REGULATORY INFORMATION DISTRIBUTION SYSTEM (RIDS)

SUBJECT: Application for amend to license NPF-21, reflecting change in
name of Washington Public Power Supply Sys to Energy
Northwest. Marked up copy of affected pages of OL for plant,
encl.

Subject: **WNP-2 OPERATING LICENSE NPF-21
REQUEST FOR AMENDMENT
LICENSEE NAME CHANGE**

REQUEST FOR AMENDMENT TECHNICAL SPECIFICATION 4.3.1.2.b
(ADDITIONAL INFORMATION)

NEW FUEL VAULT - DIAGRAM 2

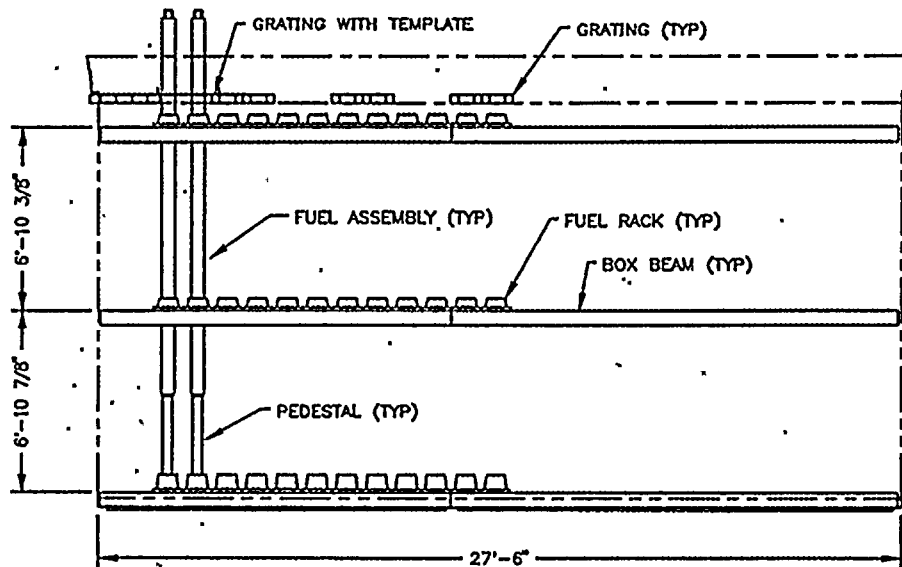
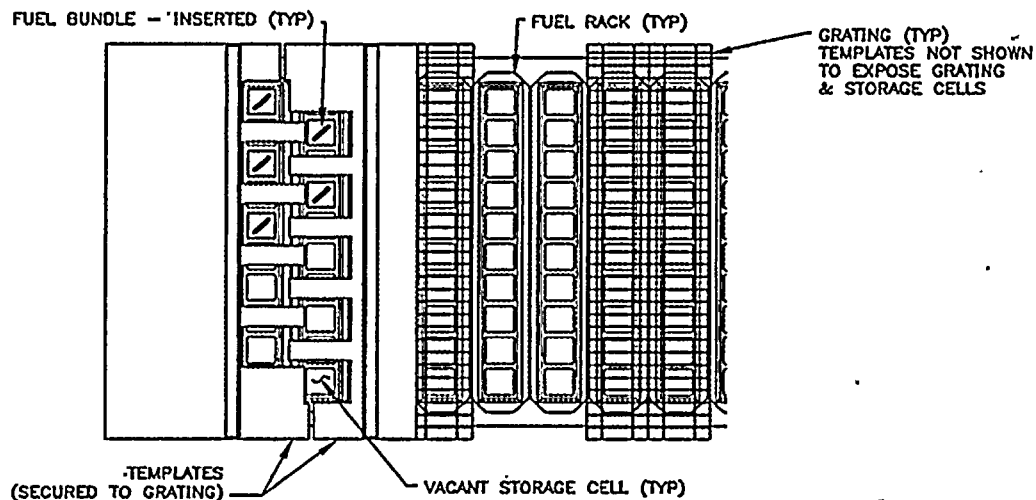
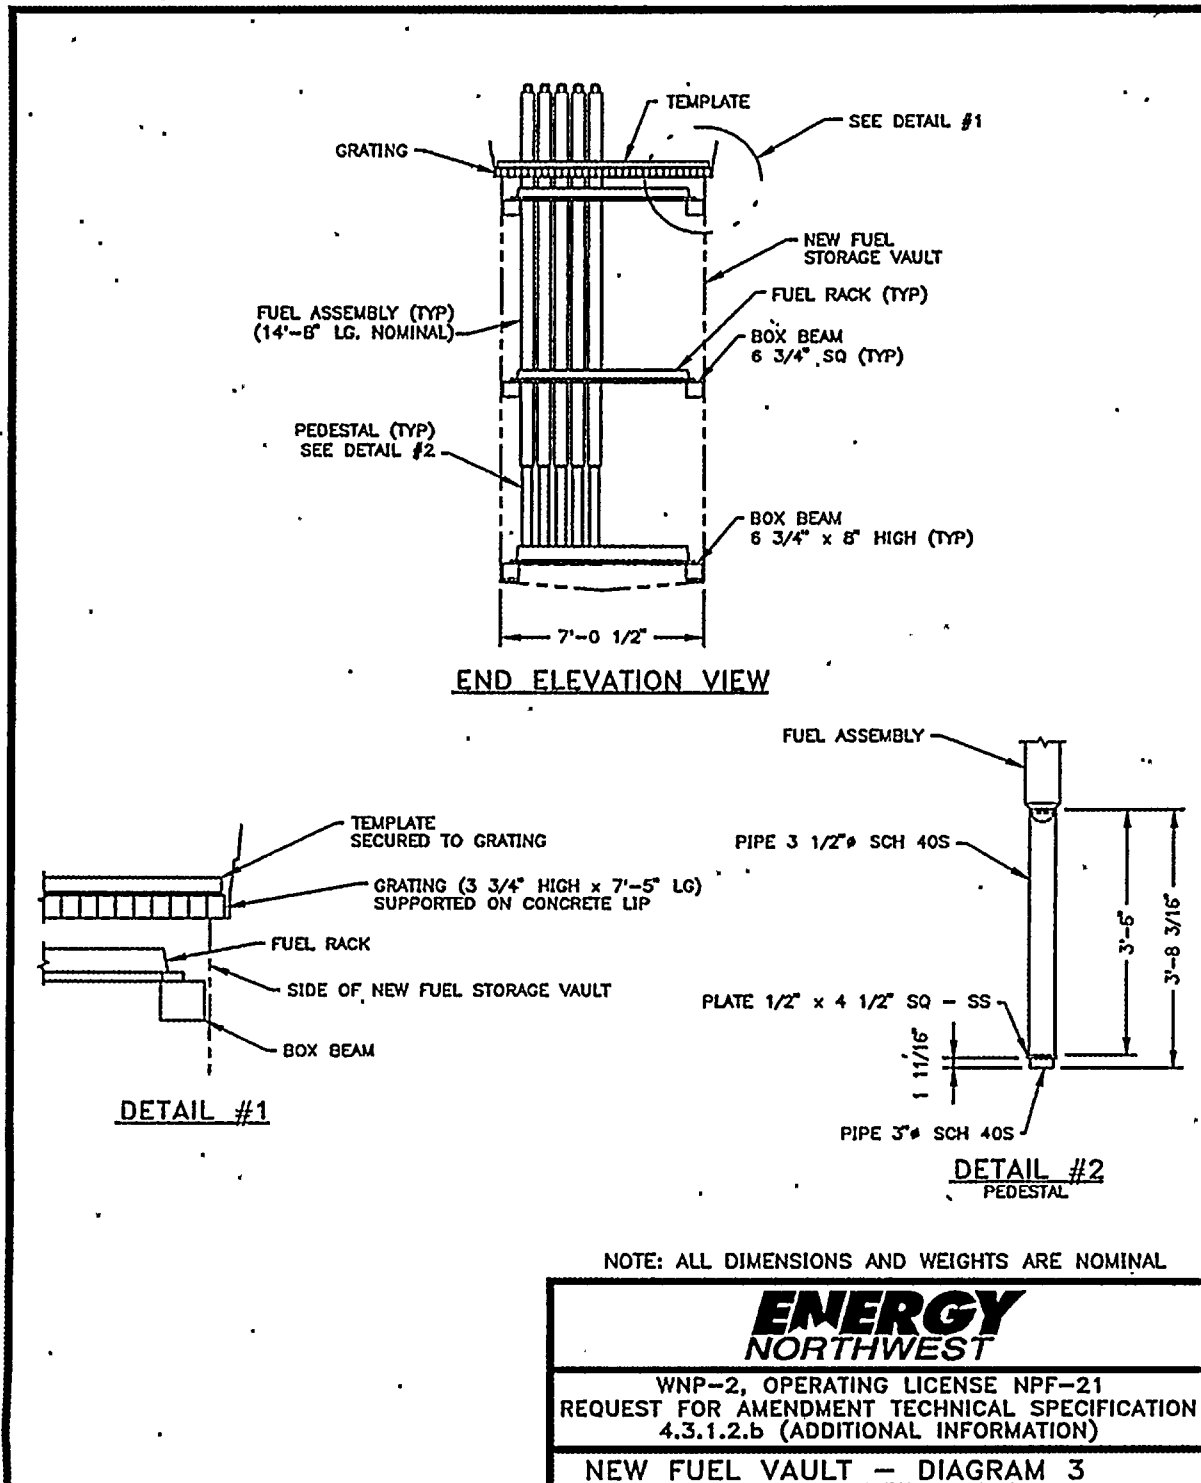
Request for Additional Information Question # 1

Request for Additional Information Question # 2

Provide a summary of the results of the above analyses and confirm that the (strength) "capacities" of the various structural elements (e.g., the pedestal, vault floor, rack walls, cover plates, etc.) are adequate to satisfy the demand imposed on them by the new configuration of the fuel assemblies as per the applicable industry codes.

A structural analysis has been performed to verify the structural integrity of the new fuel racks resulting from the new geometrical limitations of the new fuel rack support system. See attached diagrams of new fuel storage rack arrangement. The configuration control components used in the new fuel vault consist of a series of templates and working platform grating sections and a fuel support assembly (pedestal).

an assembly is fully inserted. To address the potential for uplift of a fuel assembly mounted in the pedestal, a review of the floor response spectra and a calculation of the lower fuel rack beam was performed. The vertical load on any lower fuel rack beam is reduced to less than 55% of the original load (i.e., one half of the weight of the original number of fuel assemblies, plus the weight of the pedestals). Based on a conservative natural frequency and response spectrum analysis, the forces from a safe shutdown earthquake for the new fuel assembly support system are below 1.0 g in the vertical direction. Thus, no vertical uplift of the fuel assembly will occur and the implementation of this tool (pedestal) will not have an adverse structural impact (vertically).
